Overheating Risk Assessment

Land North of Arundel Road, Fontwell

For Harlequin Developments

Appendix D – Overheating markups

Drawing Title
Floor Plans and Elevations - HT06 Semi

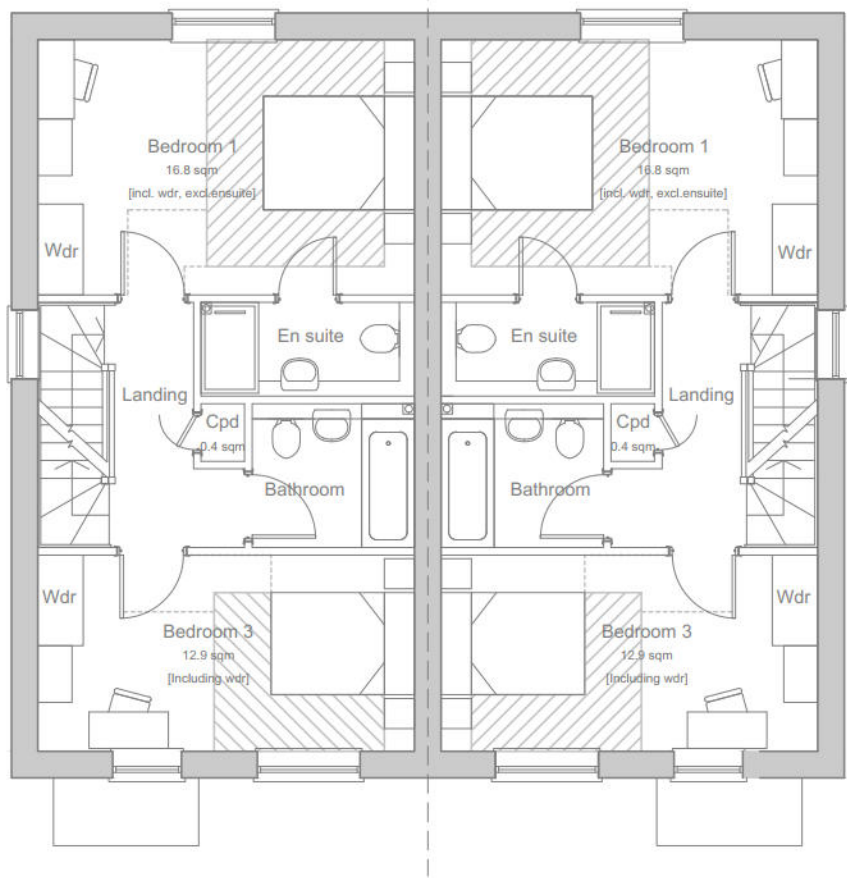
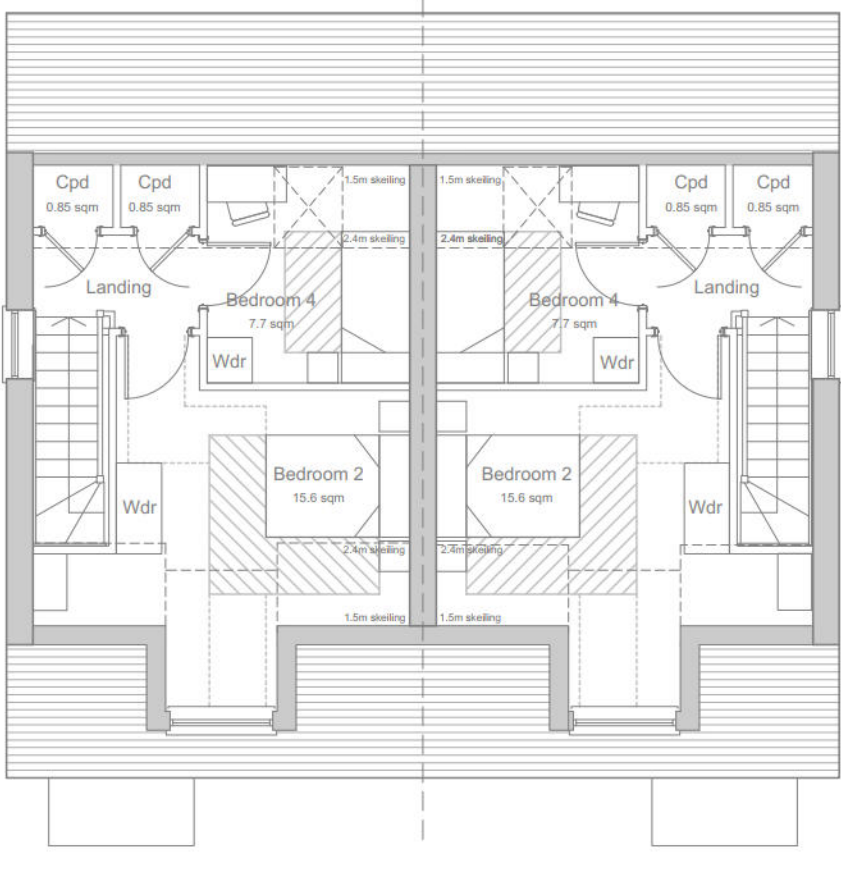
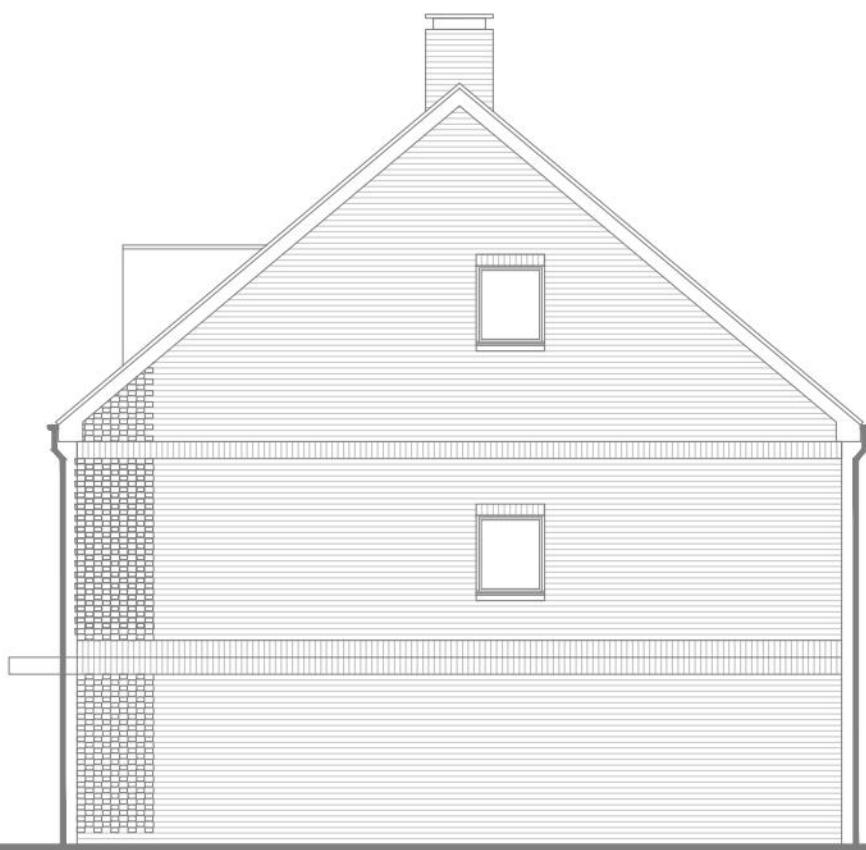
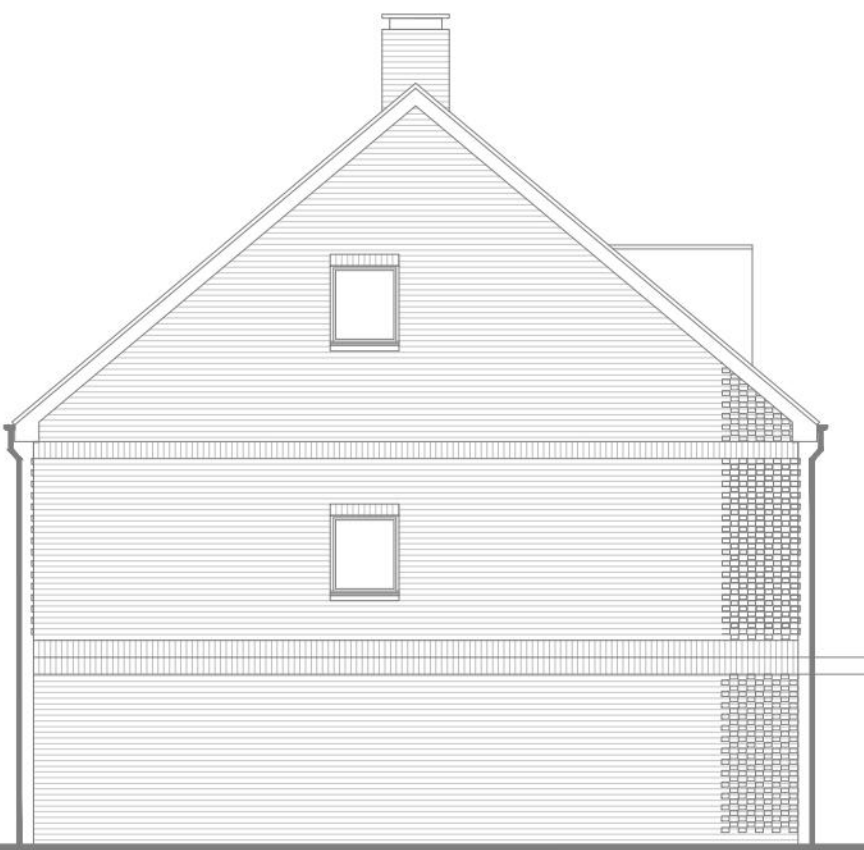
Please refer to previous pages for guidance on how to design the window assemblies of this typology.
